**Committee of Experts on the Transport of Dangerous Goods
and on the Globally Harmonized System of Classification
and Labelling of Chemicals**

**Use of the Manual of Tests and Criteria in the
context of the GHS**

**Use of the Manual of Tests and Criteria in the context of the
GHS**

**Transmitted by the Chairman of the Working Group on Explosives of
the Sub-Committee of Experts on the Transport of Dangerous Goods
(TDG Sub-Committee) on behalf of the Working Group**

Figure 20.1 (a): FLOW CHART SCHEME FOR SELF-REACTIVE SUBSTANCES AND ORGANIC PEROXIDES

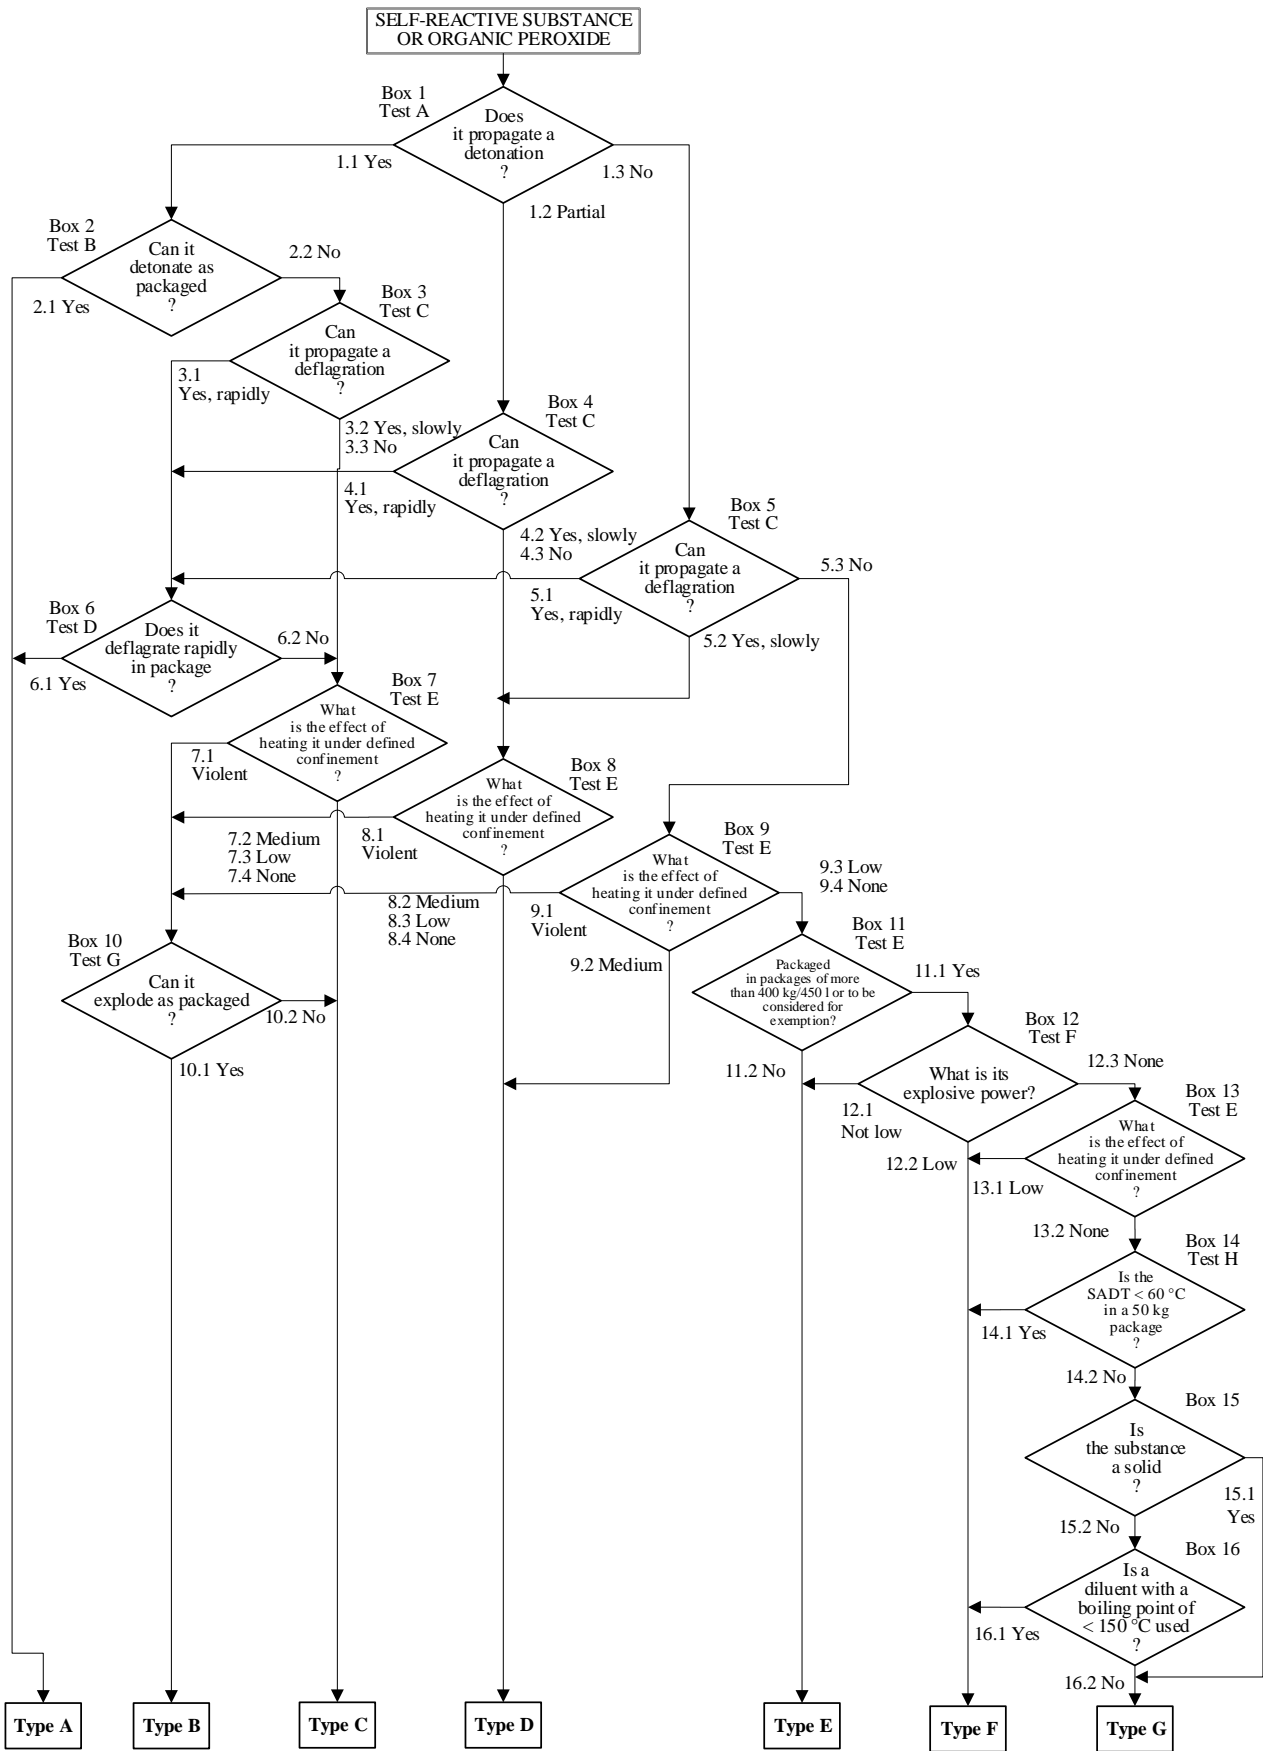
Figure 20.1 (b): ~~FLOW CHART SCHEME FOR SELF-REACTIVE SUBSTANCES AND ORGANIC PEROXIDES (cont'd)~~**Note to Figure 20.1:**

- (a) Any self-reactive substance which can detonate or deflagrate rapidly, ~~as packaged for transport, should be prohibited from transport under the provisions for self-reactive substances of Division 4.1 in that packaging (will be defined as self-reactive substance †Type A, exit box A of Figure 20.1);~~

- (a) Any organic peroxide ~~formulation~~ which, as packaged, can detonate or deflagrate rapidly, ~~as packaged for transport, should be prohibited from transport in that packaging under Division 5.2 (will be defined as organic peroxide type A, exit box A of Figure 20.1);~~

- (c) Any organic peroxide ~~formulation~~ possessing explosive properties ~~may be transported without an "EXPLOSIVE" subsidiary risk label~~ when the substance as packaged (maximum 50 kg) for transport cannot detonate or deflagrate rapidly or undergo a thermal explosion (will be defined as organic peroxide type C, ~~exit box C of Figure 20.1);~~

Figure 21.4.2.1: TNO 50/70 STEEL TUBE TEST FOR SOLIDS (TUBE TYPE A)

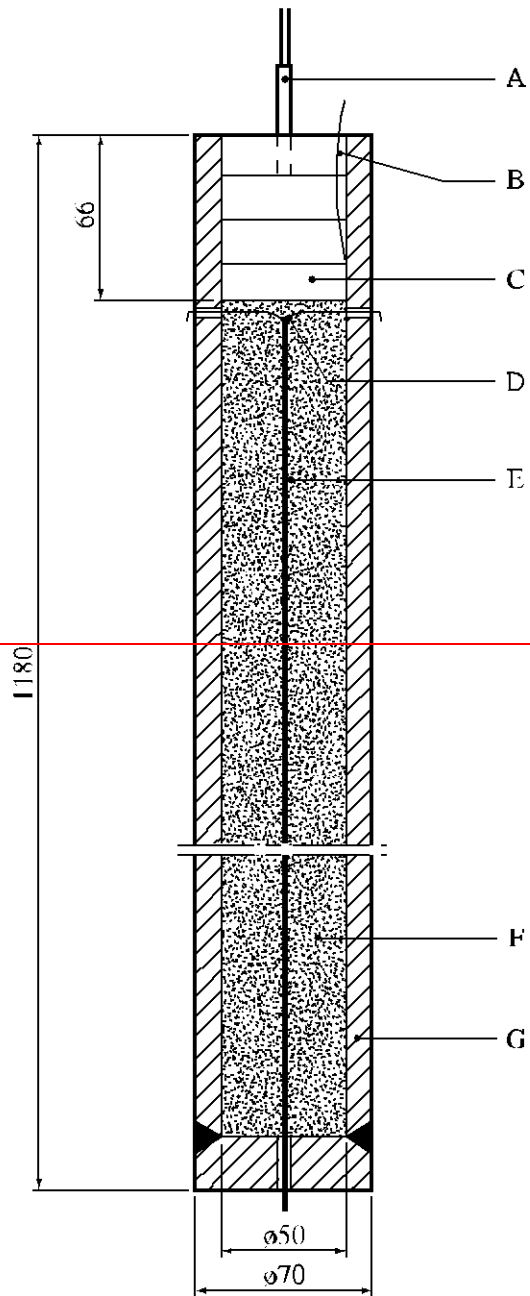
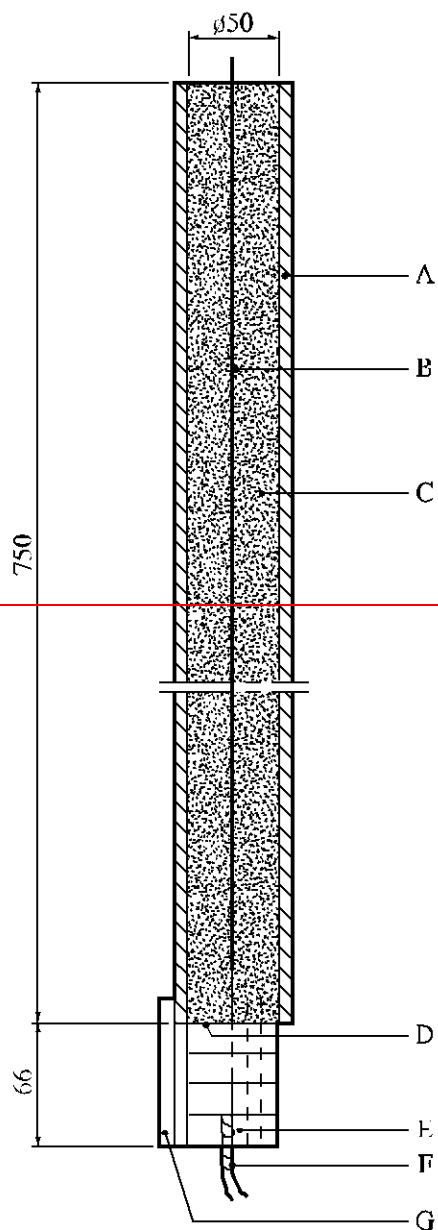
~~This test is used to measure the ability of a substance to propagate a detonation by subjecting it to a detonating booster charge under confinement in a steel tube. It may be used to answer the question in box 1 of Figure 20.1.~~

~~The apparatus consists of a seamless steel tube (e.g. material St. 35 in accordance with DIN 1629/P3), inner diameter 50 mm, wall thickness 10 mm, and length 1 160 mm (tube type A). At one end (which will be called the bottom), it is closed by welding a 20 mm thick steel plate to the tube (see Figure 21.4.2.1). The tube is instrumented, e.g. by a continuous wire velocity probe, to measure the velocity of propagation in the substance. The booster charge consists of four RDX/wax (95/5) booster charges of 50 mm diameter, mass 50 g and length 16.4 mm.~~

~~The detonability of liquids is determined with the aid of a tube similar to the tube used for solids but with a length of 750 mm. One end of the tube (called the bottom) is closed by a 0.5 mm metal plate under which the four boosters are positioned (tube type B), see Figure 21.4.2.2. The tube is held upright by means of a holder or three supports welded onto the tube. For corrosive liquids and liquids which decompose on contact with St. 35, a tube of stainless steel 316 (passivated if necessary) is used with a length of 750 mm, an internal diameter of 50 mm and an external diameter of 63 mm (tube type C).~~

Figure 26.4.5.1. HIGH-PRESSURE AUTOCLAVE

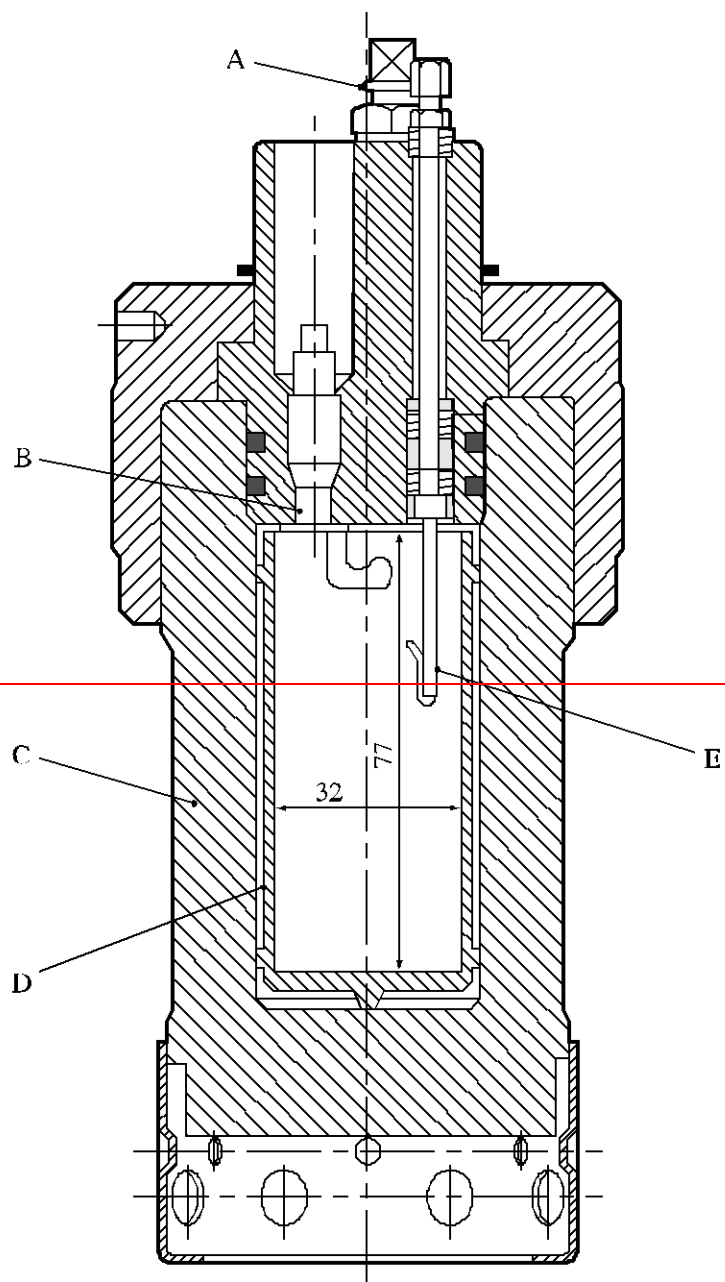
~~This test is used to measure the specific energy of a substance. Varying quantities of substance are heated in a sealed vessel and the maximum pressure rise obtained for each sample size measured. The specific energy is a function of the maximum pressure rise. The test may be used to answer the question in box 12 of Figure 20.1.~~

~~The high pressure autoclave (Figure 26.4.5.1) is a cylindrical stainless steel vessel with a capacity of 96 ml and a working pressure of 150 MPa at a temperature of 473 K. The vessel is made from stainless steel type AISI 431, has an internal diameter of 38 mm and an internal height of 84 mm. An inner sample vessel (stainless steel type AISI 316, internal diameter 32 mm and internal height 77 mm) is used inside the autoclave. A coated Ni/Cr resistance wire (specific resistance of approximately 10 ohms/m), skip wound around a piece of glass tube, is used to heat the sample by means of a constant current supply; a heating power of 50-150 W is supplied. Owing to the use of the inner vessel, the heat transfer from the substance to the autoclave is relatively small compared to the heat transfer that would exist in the situation without inner vessel. Therefore rapid heating will take place which will lead to an exothermic reaction involving self heating and explosion. The pressure-time history of the explosion is determined. The pressure is registered by means of a piezo electric transducer.~~

26.4.5.5 ~~Examples of results~~
